# **Berry and Walker Streets – North Sydney**

Section 4.55(1A)  
Modification Assessment  
(08\_0238 MOD 13)

August 2019

**Figure 3** | Proposed Spring Western Elevation

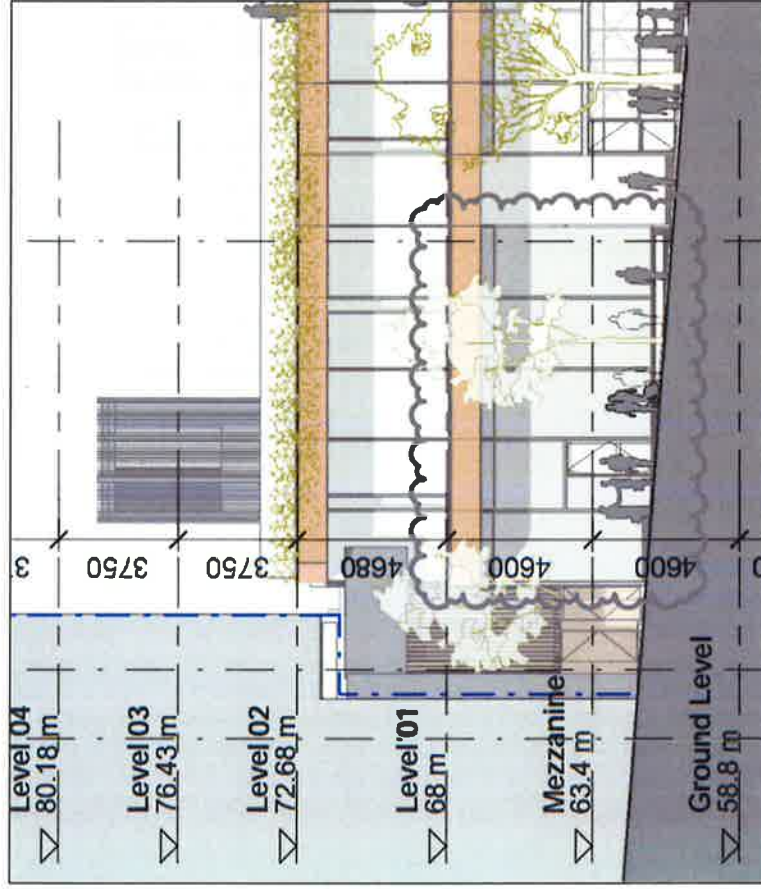
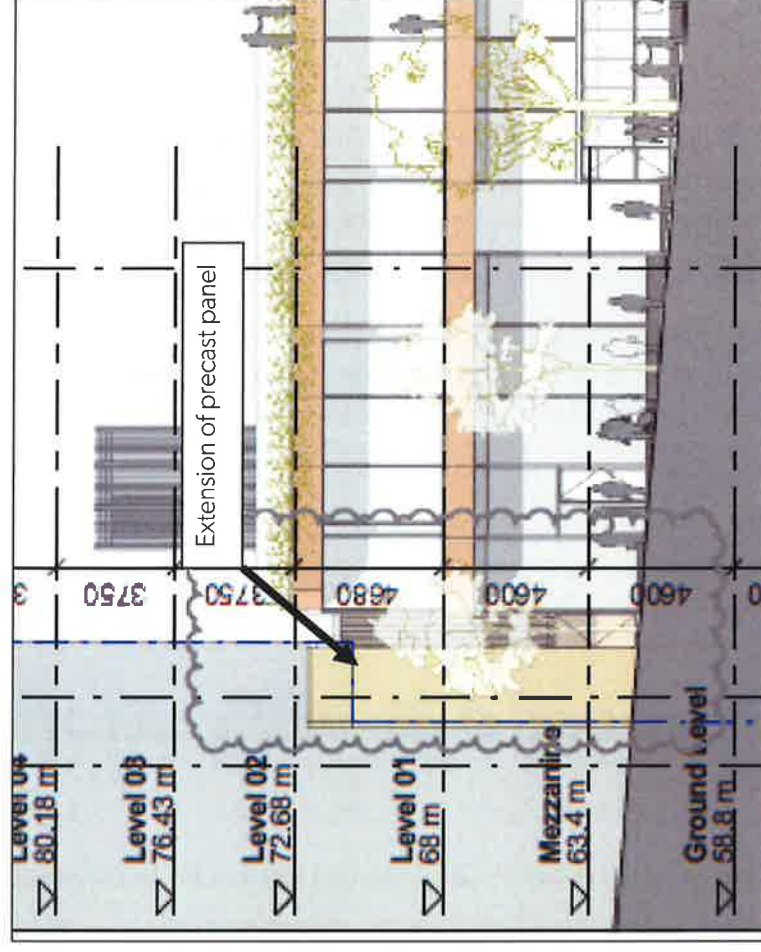
Façade changes	<ul style="list-style-type: none"><li>• The proposal seeks to extend a precast panel on the eastern and western elevations, as shown in Figure 3.</li></ul>	No additional conditions or amendments are

- The Department notes the proposed amendments are considered necessary. within the approved building envelope, relate to a minor portion of the facade and would not result in any significant impacts on the overall design or level of street activation.
- Council raised no concerns about the proposed facade changes.
- The Department has considered the proposed modification, and is satisfied it would not result in any adverse visual or amenity impacts.

**Figure 5** | Proposed design of Berry Square

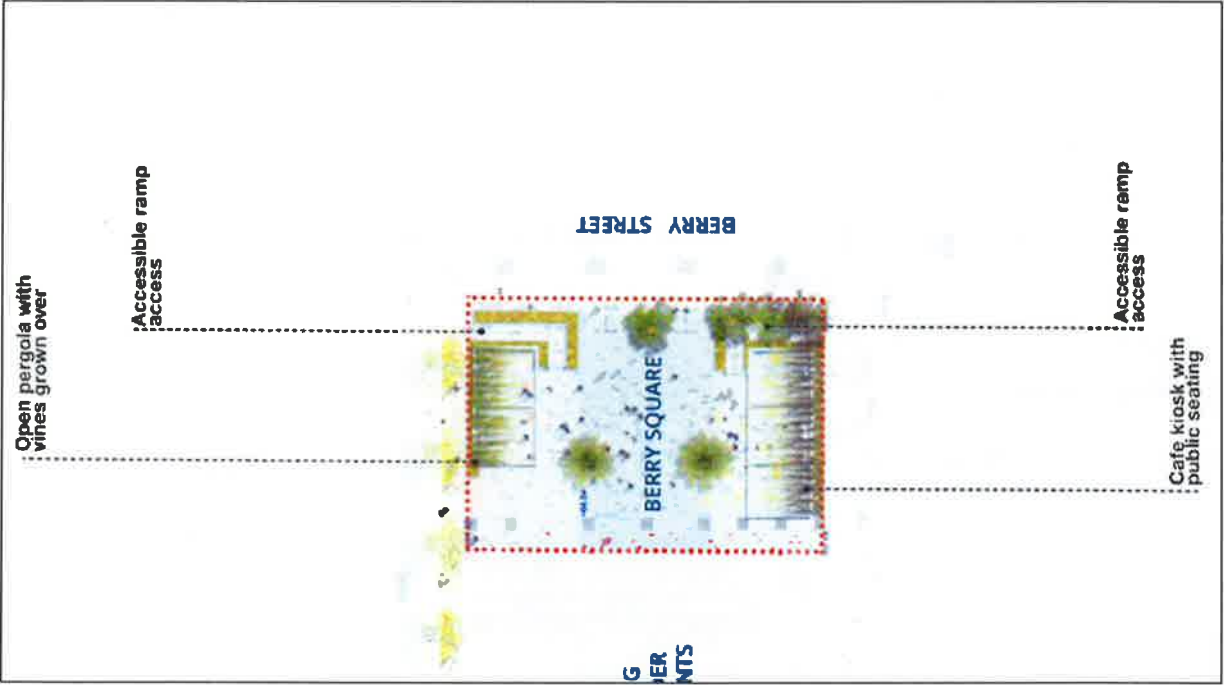
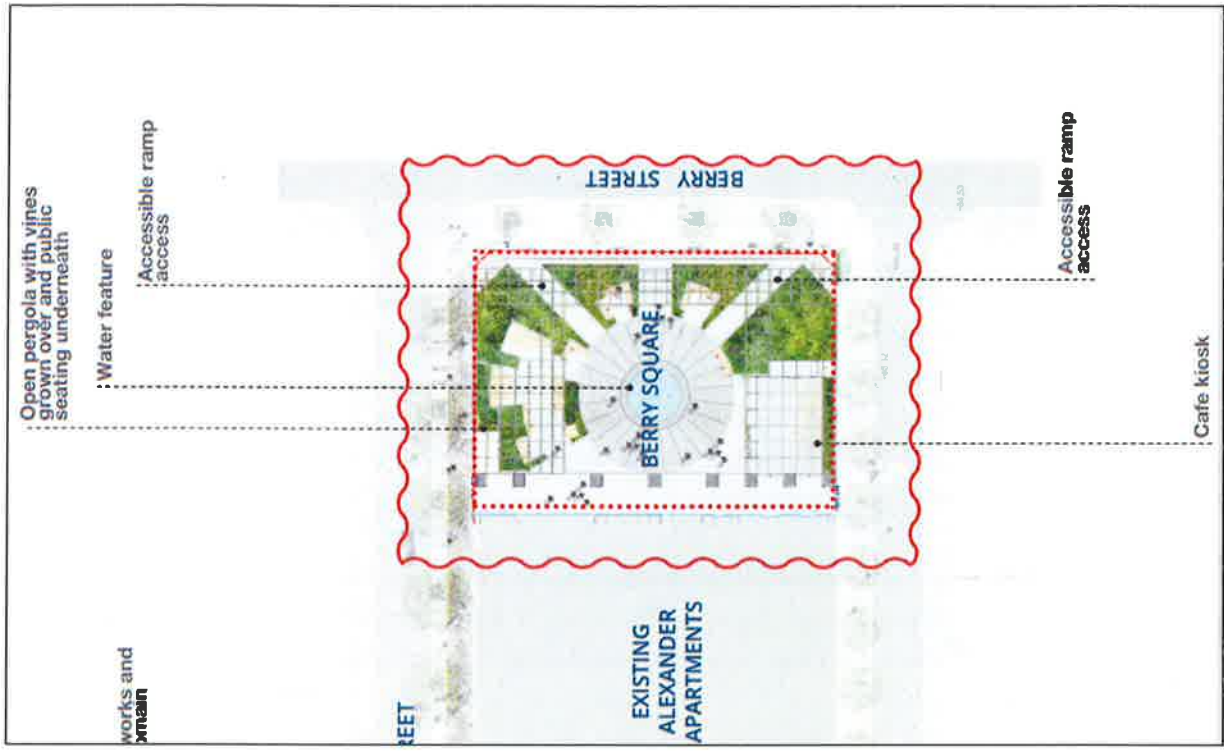
**Council** advised that further details regarding the landscaping works for Berry Square (materials, planting species etc) could be submitted to Council before approval of the final landscape plan as required by Condition B38. Accordingly, Council raised no objections to the amended landscape design for Berry Square or the minor façade amendments.

Issue	Findings	Recommended Condition
Public Domain	<ul style="list-style-type: none"><li>• The request seeks approval to amend the landscape design of Berry Square.</li><li>• The Department notes the proposal includes the addition of a water feature, public seating and changes to planting and paving, as outlined in <b>Figure 5</b>.</li><li>• The Department considers the proposed modifications to the landscaping are acceptable as:<ul style="list-style-type: none"><li>○ the addition of a water feature and additional seating would improve public amenity</li><li>○ the area for planting is consistent with the approved landscape plan</li><li>○ no changes to the accessible ramps are proposed</li><li>○ Council raised no objection to the proposal.</li></ul></li><li>• The Department also notes the final detailed design of Berry Square must be approved by Council, as required by Condition B38. The condition requires the final landscape and public domain plans to be submitted to and approved by North Sydney Council prior to any works. This will provide Council with an opportunity to approve the detailed design of the landscaping including the paving materials, planting species and structures.</li><li>• The Department is therefore satisfied the proposal is acceptable, and would not affect usability or amenity of the space.</li></ul>	No additional conditions or amendments are considered necessary.
